**CERTIFICATE OF APPROPRIATENESS**

**Property:** 321 Heights Boulevard, Lot 4 and Tract 5, Block 313, Houston Heights Subdivision. The property consists of two lots – Lot 4 is 7500 sq ft (50' x 150') and is developed only with a concrete parking pad. Tract 5 is 7450 sq ft corner lot containing a historic 2,751 square foot two-story wood frame single-family residence. The owner is proposing to build the new structure on Lot 4.

**Proposal:** New Construction – Construct a two-story 2,536 square foot residence and integrated garage.

**Recommendation:** Denial - does not satisfy criteria 1, 2, 3, 4

**EAST ELEVATION – FRONT FACING HEIGHTS BOULEVARD**

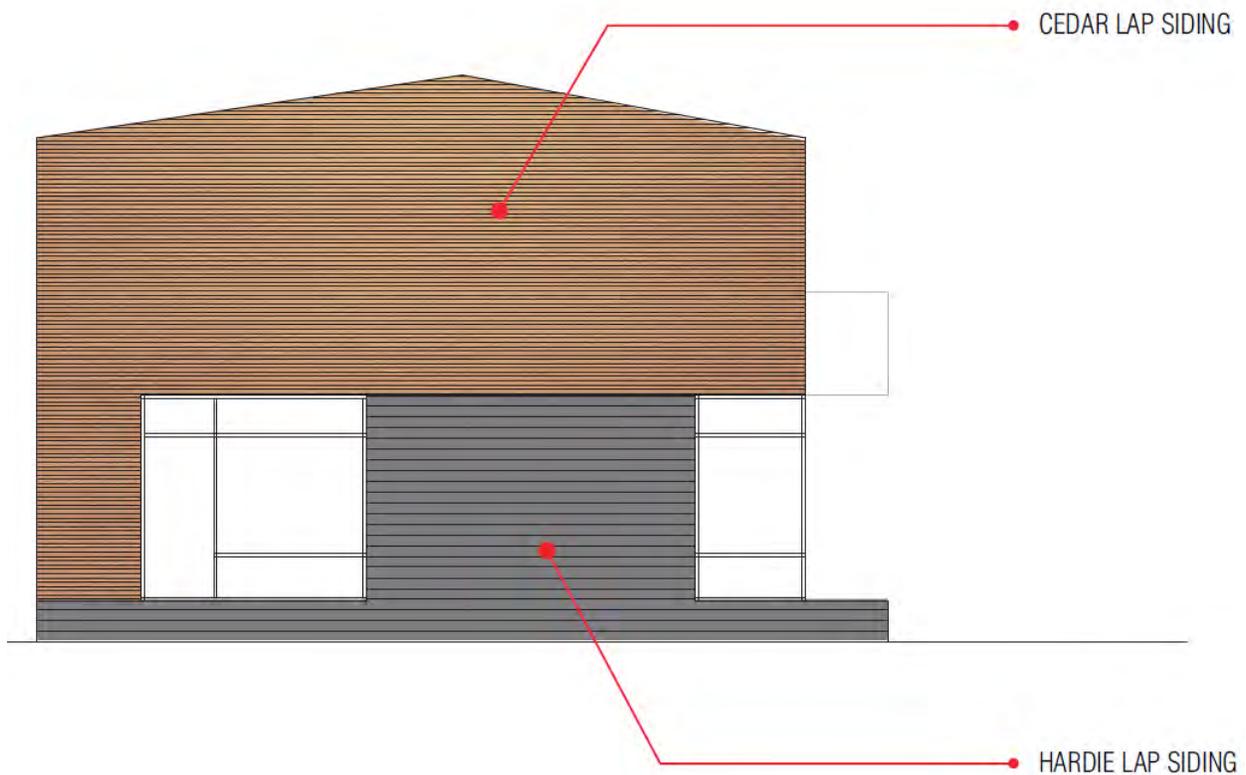
The fenestration pattern on the façade and low roof pitch of the proposed new residence and integrated garage is not compatible with the existing contributing structures within the Houston Heights Historic District South. A more typical fenestration pattern and traditional roof pitch should be incorporated. Although the proposed materials of cedar and cementitious lap siding are compatible, the way in which they are integrated into the design, with the use of screens partially obscuring windows and portions of the structure, is not compatible with other contributing structures. The integration of a partial wrap around balcony facing the street, a side facing front door on the rear half of the structure, and a side facing garage door located on the front half of the structure are also not compatible with other contributing structures.

The 42' width of the proposed structure is wider than what is typically found in the Houston Heights Historic District South. A more compatible width would not typically exceed 35'. The proposed roofline does not match typical district roofline configurations. The proposed roof has shallow pitches of ¼":12 and 2:12, with more typical roofs having steeper pitches ranging from 5:12 - 8:12.

*The proposed eave height 26.5' is significantly higher than that of a typical contributing house within the Houston Heights Historic District South. A more compatible eave height for a house would be around 23'.*

*If a residence is desired, then the proposed building should meet the required proportions and scale of contributing structures located in the district and match typical setbacks. The exterior features should also be compatible with other historic contributing structures in material, roof pitch, garage placement, front door and porch location, etc.*
